Waterside House, Uxbridge

Class 0 Change of Use Application

Report Title: Class 0 Change of Use Application

TPM Studio have been asked on behalf of Permitted Developments Investments No. 7 Ltd to prepare and submit a statement in support of the Section 73 Application relating to the proposed redevelopment of Waterside House in Uxbridge.

Proposed Amended Plan REF: 1153-P130-0_GA PROPOSED GROUND FLOOR PLAN

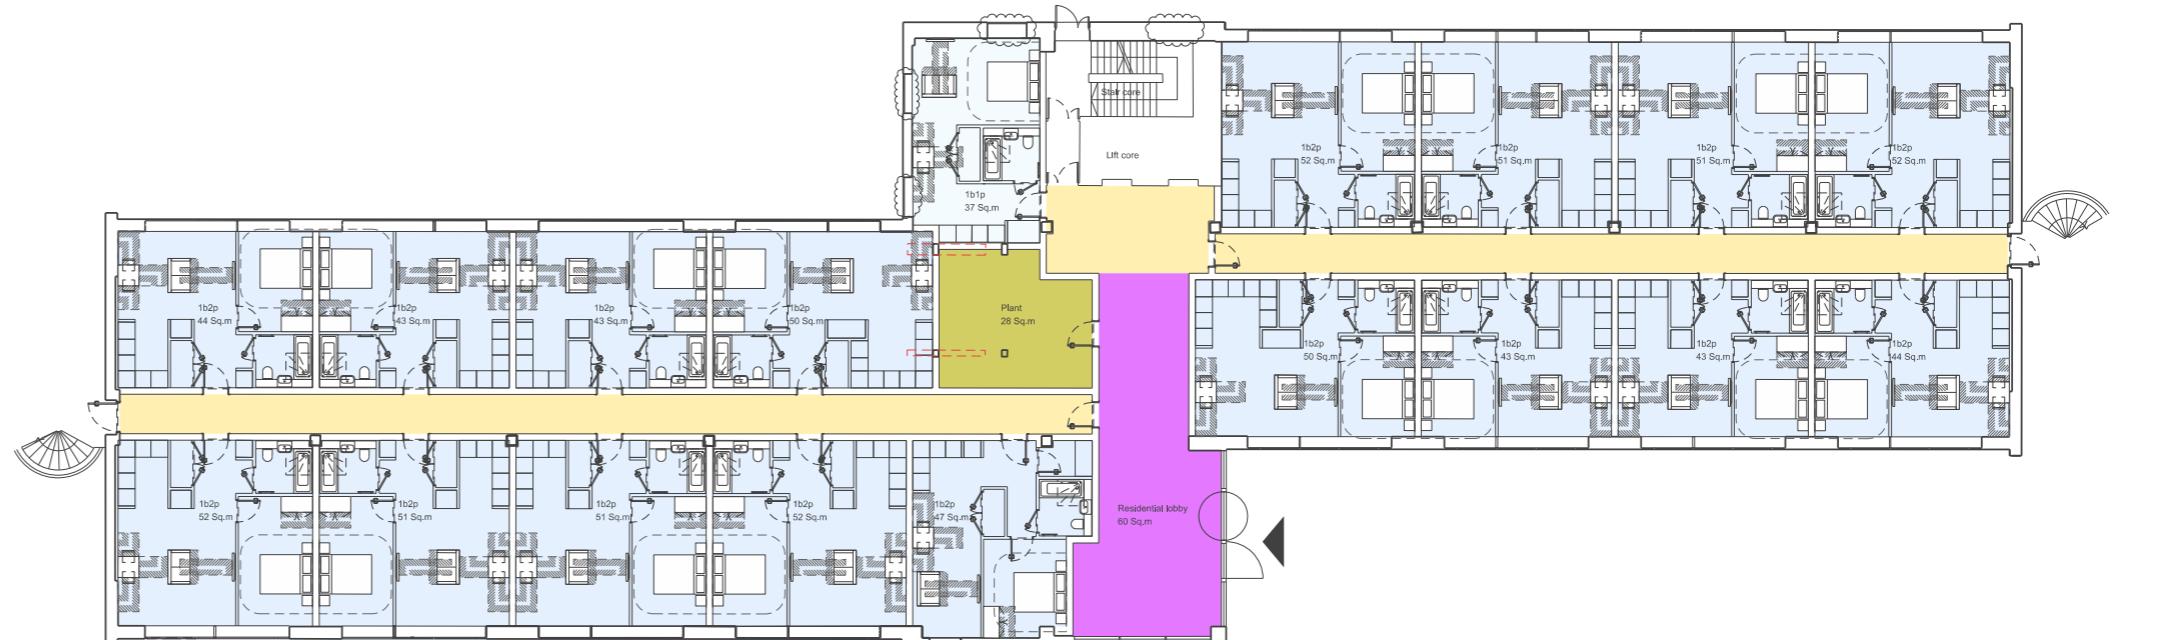
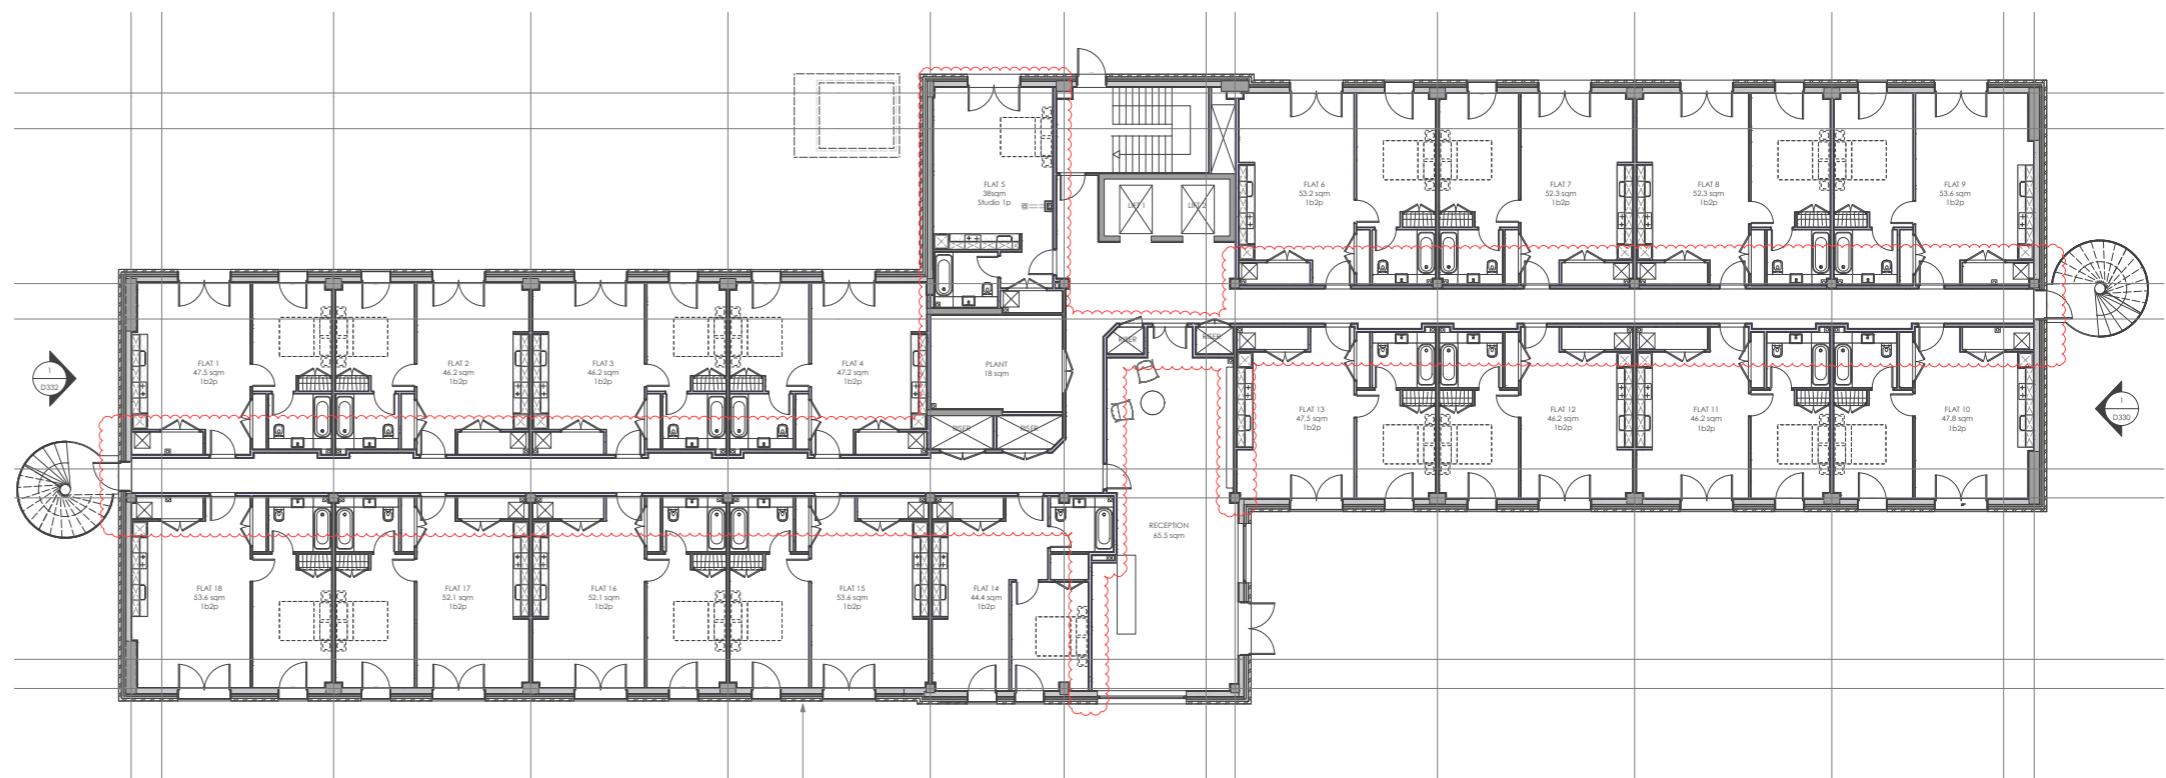
- The arrangement of apartments on the ground, floors, is consistent with the consented scheme where the predominant changes occur along the internal wall of apartments where the width of the corridor has narrowed slightly to allow for generally 1200mm clear wall-to-wall, with passing spaces 1500mm in width. The naming conventions of the individual apartments is consistent with the NDSS and the previous application.

- Minor rationalisation of the ground floor reception and 1b2p apartment adjacent where the size and location of the existing structure is now better understood following strip out of the existing building.

- Minor internal modifications of apartments to create improved, more open plan living accommodation, with better access to storage.
- Rationalised arrangement of bathrooms and coordination of services between the ground and fourth floors.

- Modification of Apartment 5 (left-hand side of the stair core) owing to the position of the existing primary structural fin walls which cannot be removed.

- To the north and east elevations, where windows were previously not identified on plan these are now captured.
- Revised riser positions and sizes following MEP advice.

1.2 First and Second Floor Layout

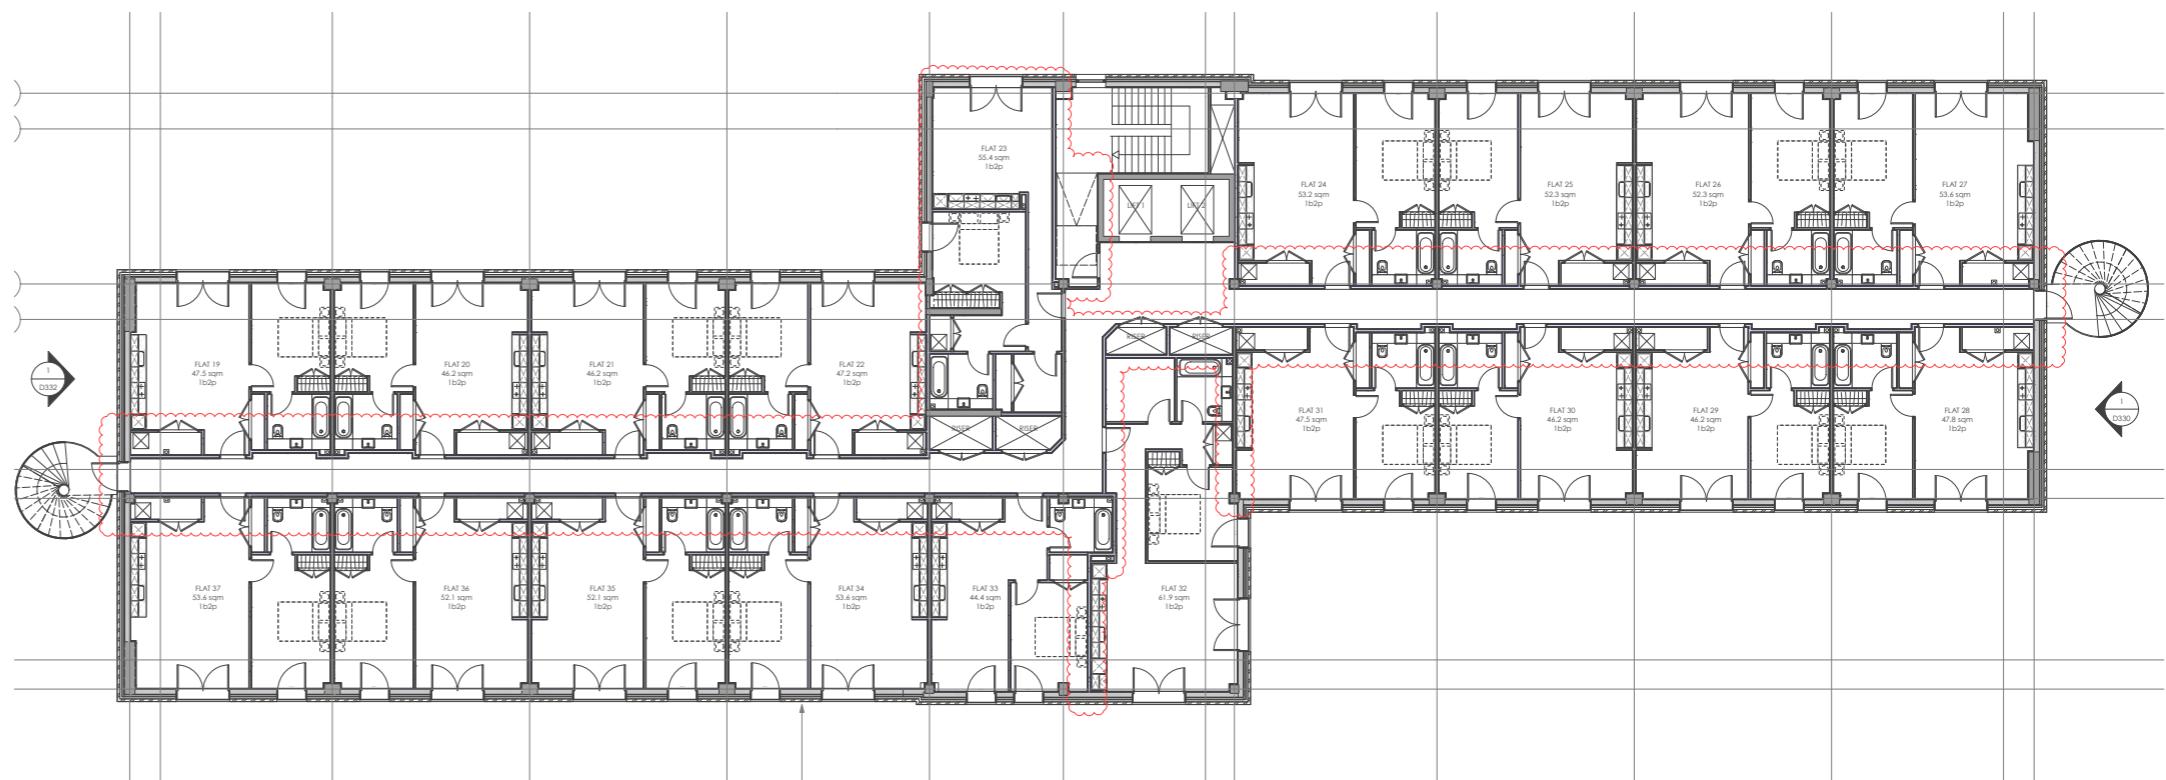
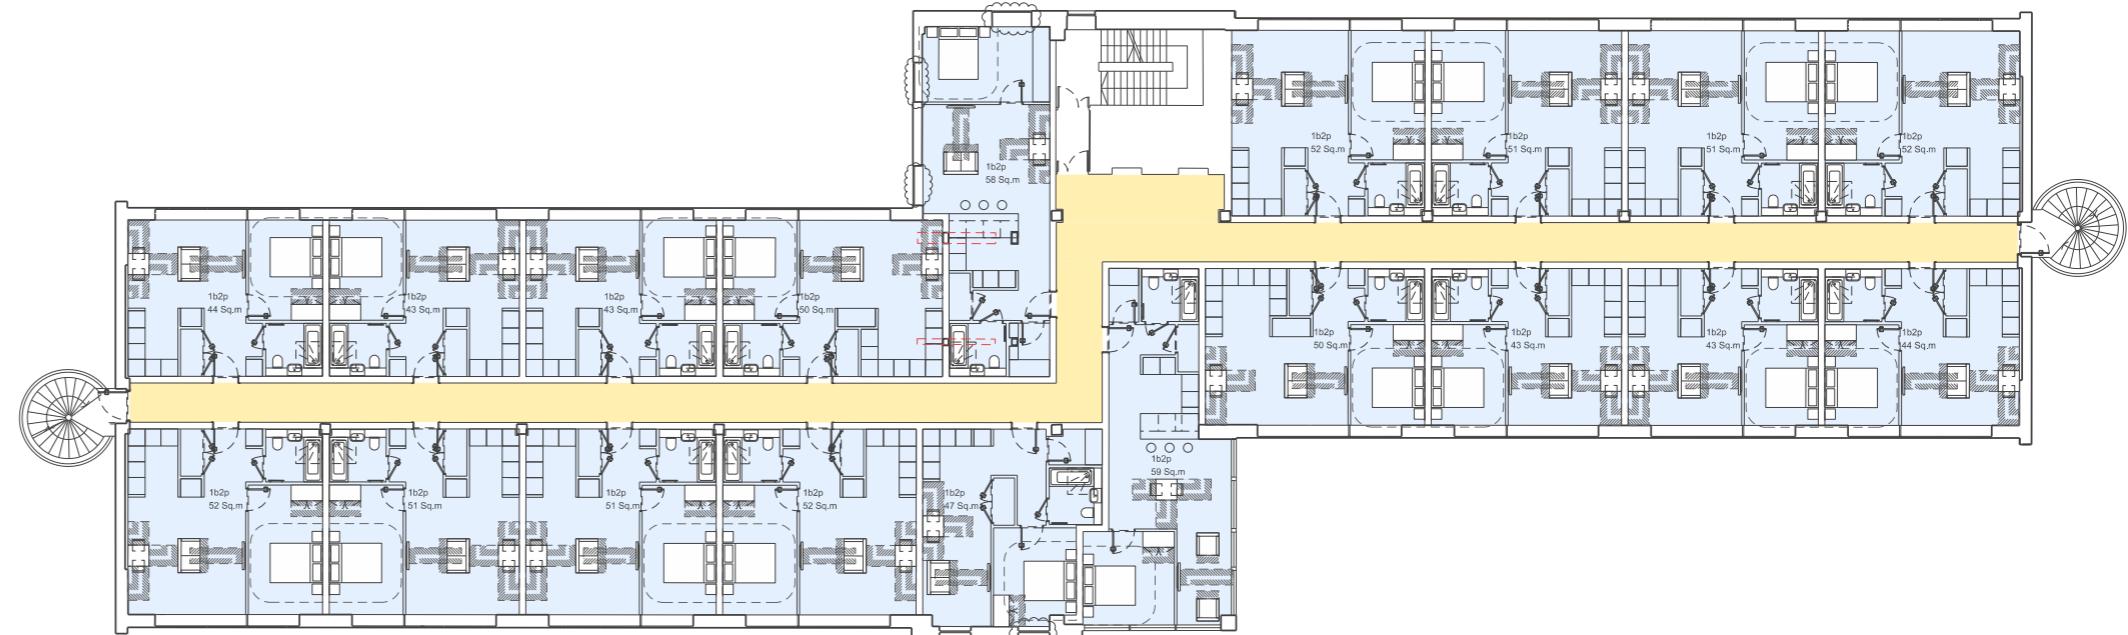
- The arrangement of apartments on the first and second floors are consistent with the consented scheme where the predominant changes occur along the internal wall of apartments where the width of the corridor has narrowed slightly to allow for generally 1200mm clear wall-to-wall, with passing spaces 1500mm in width. The naming conventions of the individual apartments is consistent with the NDSS and the previous application.

- Inclusion of a localised ramp adjacent to the lift core and between the stair landing and the lift lobby. The ramp allows for level differences between the slab and stair landing.

- Minor internal modifications of apartments to create improved, more open plan living accommodation, with better access to storage.
- Rationalised arrangement of bathrooms and coordination of services between the ground and fourth floors.

- Modification of Apartment 23/42 (left-hand side of the stair core) owing to the position of the existing primary structural fin walls which cannot be removed.

- To the north and east elevations, where windows where previously not identified on plan these are now captured.
- Inclusion of risers where these were previously missed of the arrangement plan.

- Modification of the internal layout of apartment 32/51, following changes to the arrangement of the service risers.

Proposed Amended Roof Plan REF: 1153-P136-0_GA PROPOSED ROOF PLAN

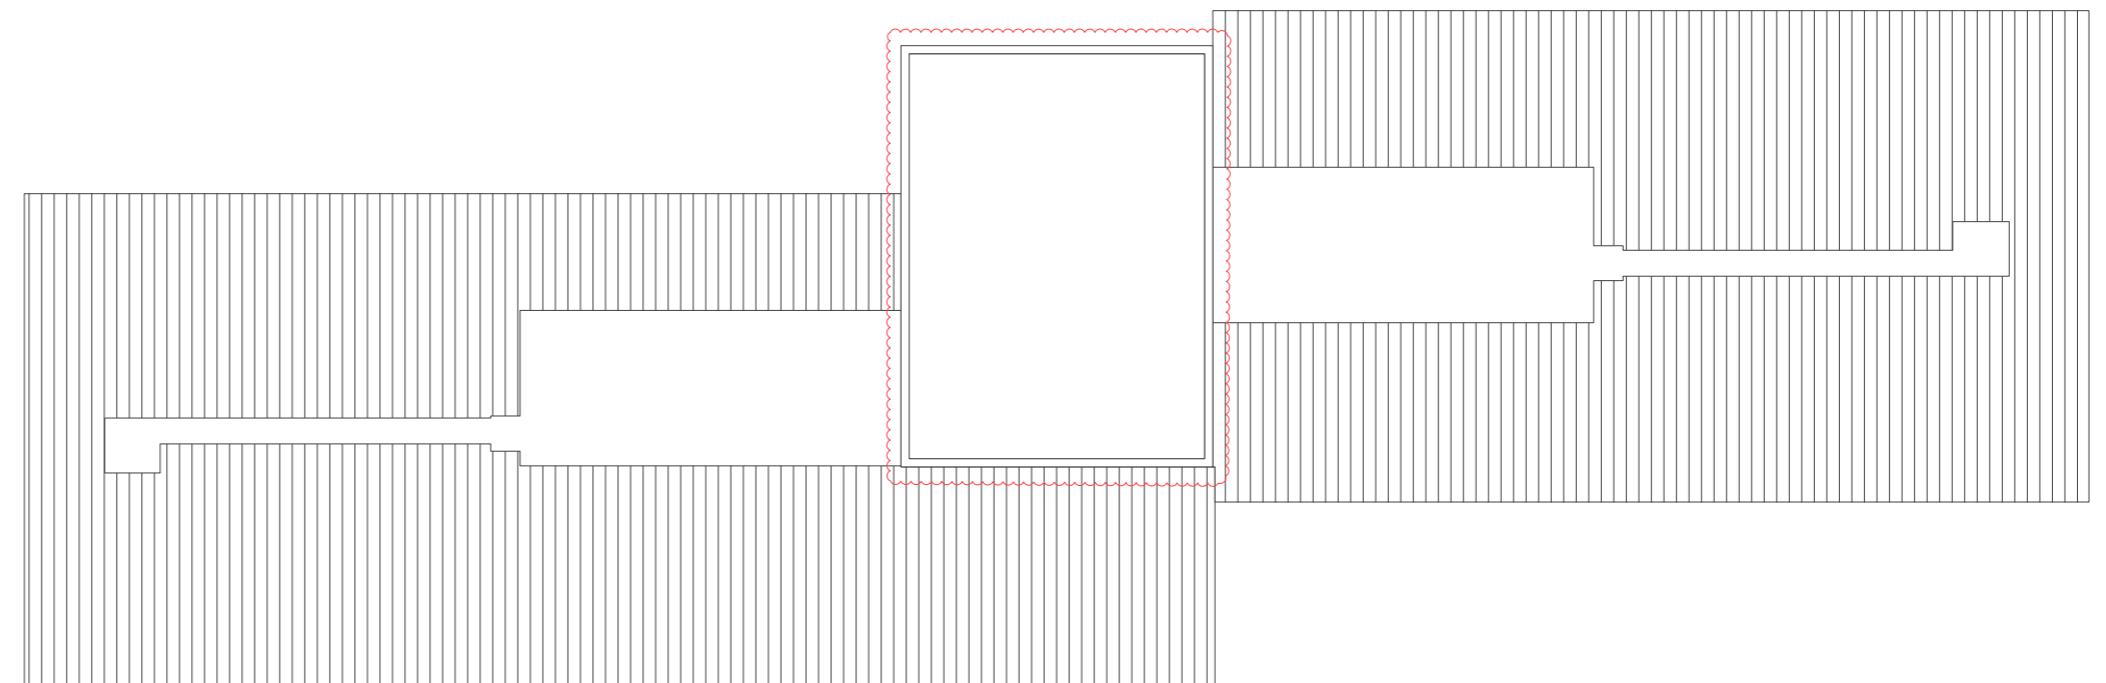
- As a result of a further application in which the addition of two stories have been approved, the adjacent two flats have been made redundant. Therefore, this amendment aims to omit these within its related application.
